Addendum 15 — Regulation No. 16

Revision 8 — Amendment 3

Supplement 8 to the 06 series of amendments — Date of entry into force: 22 June 2017

Uniform provisions concerning the approval of:

"Figure 1

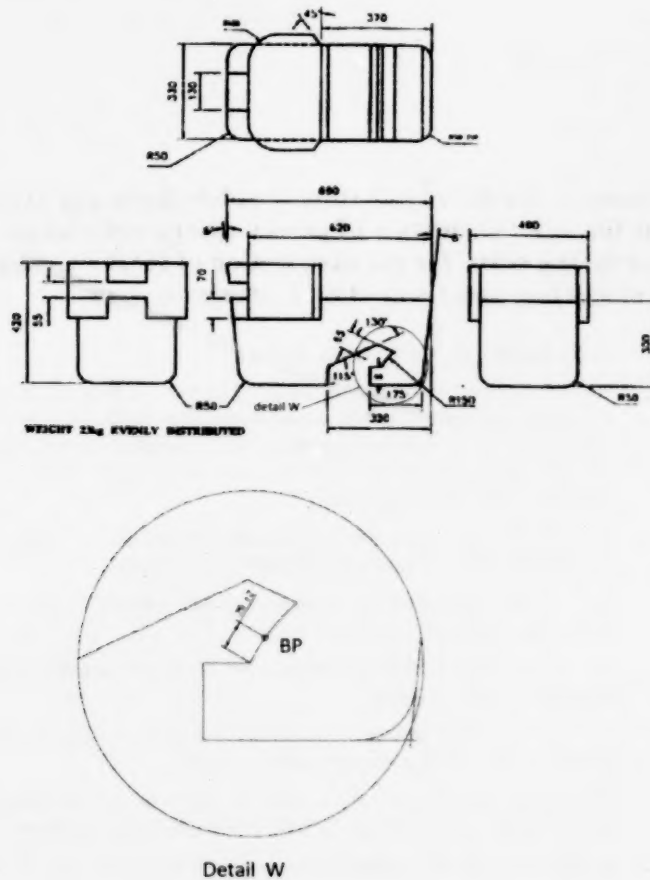
- "3.2. The lap portion of the belt shall touch the fixture on both sides at the rear of the lap belt path (see Figure 3). The seat belt webbing shall always cover the points BP on the left and right ends of the curved edge; the exact position of point BP on the curved edge is indicated in detail W of Figure 1."

Figures 1 to 3, amend to read:
